Subject: ANNEXES to the Commission Delegated Regulation (EU) .../... amending
Delegated Regulation (EU) No 44/2014, as regards vehicle construction
and general requirements, and Delegated Regulation (EU) No 134/2014,
as regards environmental and propulsion unit performance requirements
for the approval of two- or three-wheel vehicles and quadricycles

ANNEXES 1 to 2

Commission Delegated Regulation (EU) .../...

amending Delegated Regulation (EU) No 44/2014, as regards vehicle construction and general requirements, and Delegated Regulation (EU) No 134/2014, as regards environmental and propulsion unit performance requirements for the approval of two- or three-wheel vehicles and quadricycles

Figure 10-1

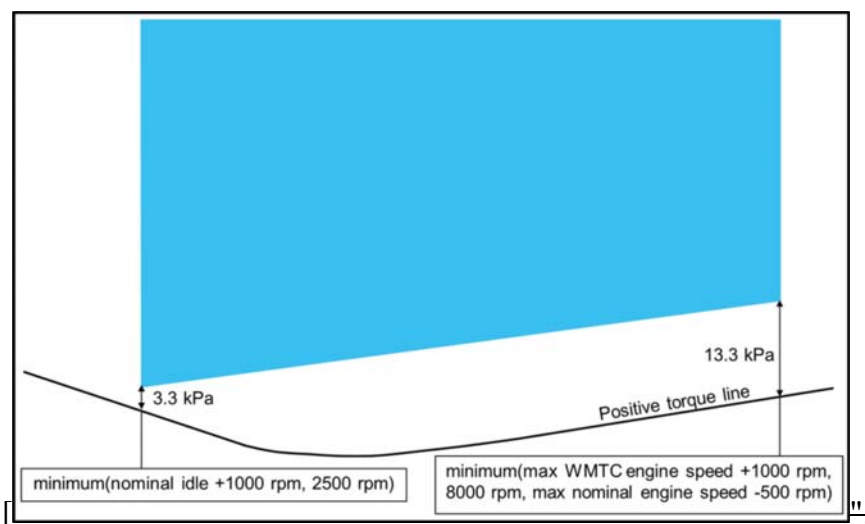
(b) point 3.3.2.2. is replaced by the following:

"3.3.2.2. Engine misfire

The presence of engine misfire in the engine operating region bounded by the following lines:

- (a) low speed limit: A minimum speed of 2500 min^{-1} or normal idle speed $+1000 \text{ min}^{-1}$, whichever is the lower
- (b) high speed limit: A maximum speed of 8000 min^{-1} or 1000 min^{-1} greater than the highest speed occurring during a type I test cycle or maximum design engine speed minus 500 min^{-1} , whichever is lower
- (c) a line joining the following engine operating points:
 - (i) a point on the low speed limit defined in (a) with the engine intake vacuum at 3.3 kPa lower than that at the positive torque line;
 - (ii) a point on the high speed limit defined in (b) with the engine intake vacuum at 13.3 kPa lower than that at the positive torque.

The engine operation region for misfire detection is reflected in figure 10-1.

Standard Bench Cycle

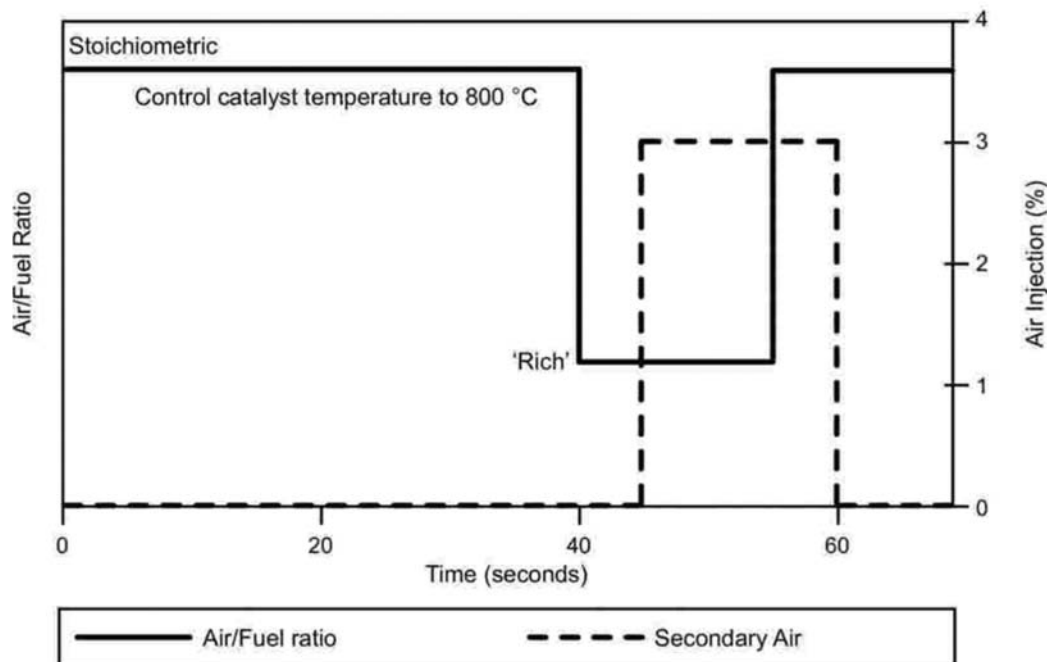
The standard ageing durability procedure consists of ageing a catalyst/oxygen sensor system on an ageing bench which follows the standard bench cycle (SBC) described in this Appendix. The SBC requires use of an ageing bench with an engine as the source of feed gas for the catalyst. The SBC is a 60-second cycle which is repeated as necessary on the ageing bench to conduct ageing for the required period of time. The SBC is defined based on the catalyst temperature, engine air/fuel (A/F) ratio, and the amount of secondary air injection which is added in front of the first catalyst.

Time (seconds)	Engine Air/Fuel Ratio	Secondary Air Injection
1-40	Stoichiometric with load, spark timing and engine speed controlled to achieve a minimum catalyst temperature of 800 °C	None
41-45	'Rich' (A/F ratio selected to achieve a maximum catalyst temperature over the entire cycle of 890 °C or 90 °C higher than lower control	None

temperature)	
46-55	'Rich' (A/F ratio selected to achieve a maximum catalyst temperature over the entire cycle of 890 °C or 90 °C higher than lower control temperature)	3 % ($\pm 0,1$ %)
56-60	Stoichiometric with same load, spark timing and engine speed as used in the 1-40 sec period of the cycle	3 % ($\pm 0,1$ %)

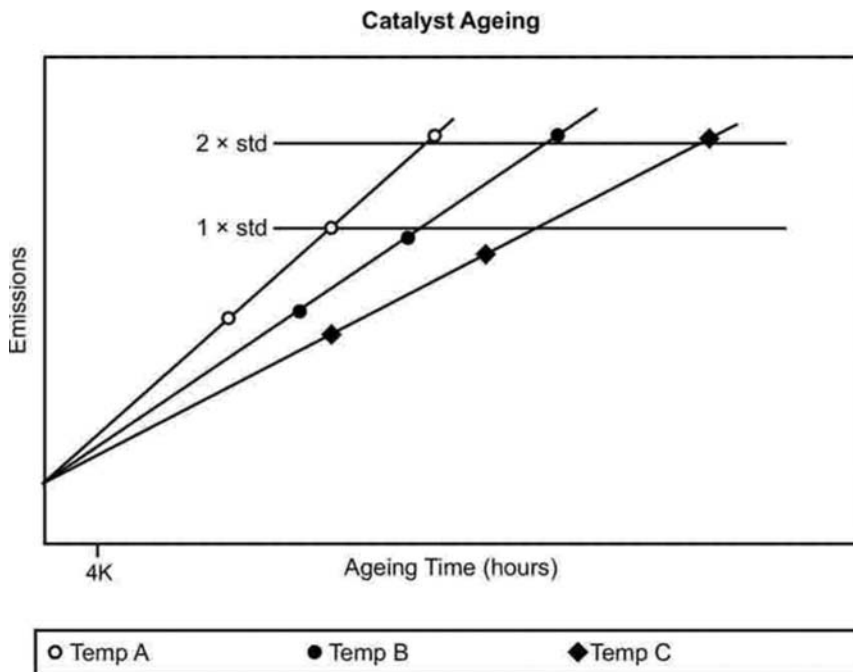
- 3.6. Setup. The engine speed, load, and spark timing are selected to achieve a catalyst bed temperature of 800 °C (± 10 °C) at steady-state stoichiometric operation.

The air injection system is set to provide the necessary air flow to produce 3,0 % oxygen ($\pm 0,1$ %) in the steady-state stoichiometric exhaust stream just in front of the first catalyst. A typical reading at the upstream A/F measurement point (required in point 5) is lambda 1,16 (which is approximately 3 % oxygen).

With the air injection on, set the 'Rich' A/F ratio to produce a catalyst bed temperature of 890 °C (± 10 °C). A typical A/F value for this step is lambda 0,94 (approximately 2 % CO).

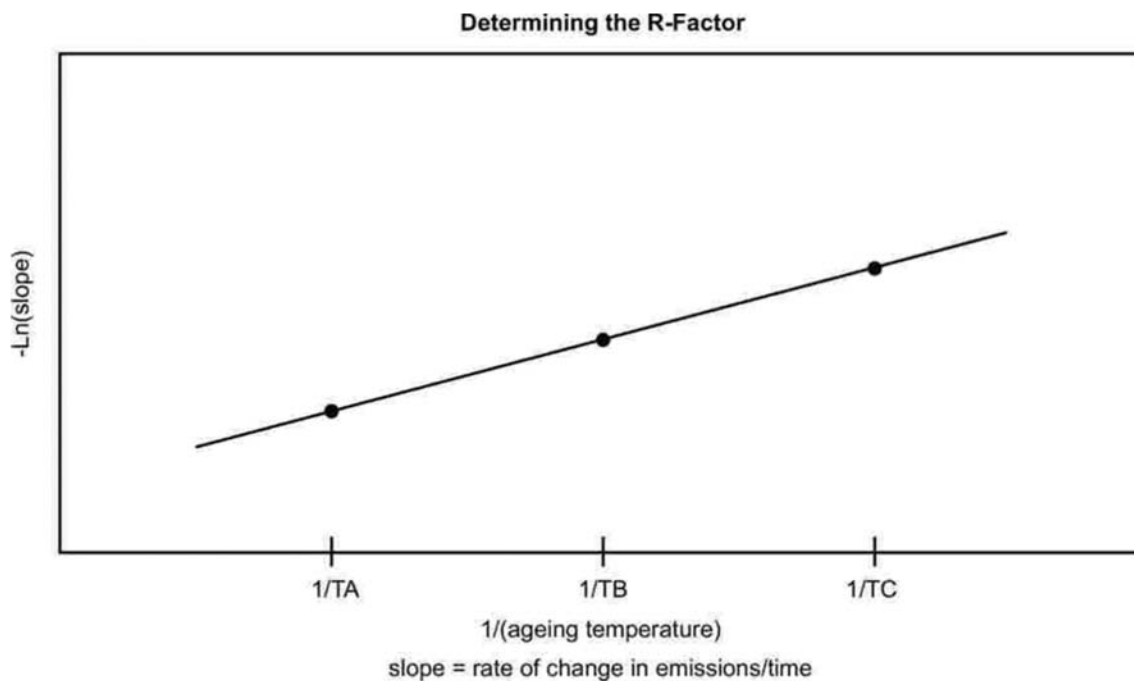
- 4.4. Plot emissions (or catalyst inefficiency) versus ageing time for each catalyst. Calculate the least-squared best-fit line through the data. For the data set to be useful for this purpose the data should have an approximately common intercept [between 0 and 6 400 km. See the following graph for an example.]

- 4.5. Calculate the slope of the best-fit line for each ageing temperature.
 - 4.6. Plot the natural log (ln) of the slope of each best-fit line (determined in point 4.5) along the vertical axis, versus the inverse of ageing temperature ($1/(\text{ageing temperature, deg K})$) along the horizontal axis, Calculate the least squared best-fit lines through the data. The slope of the line is the R-factor. See the following graph for an example
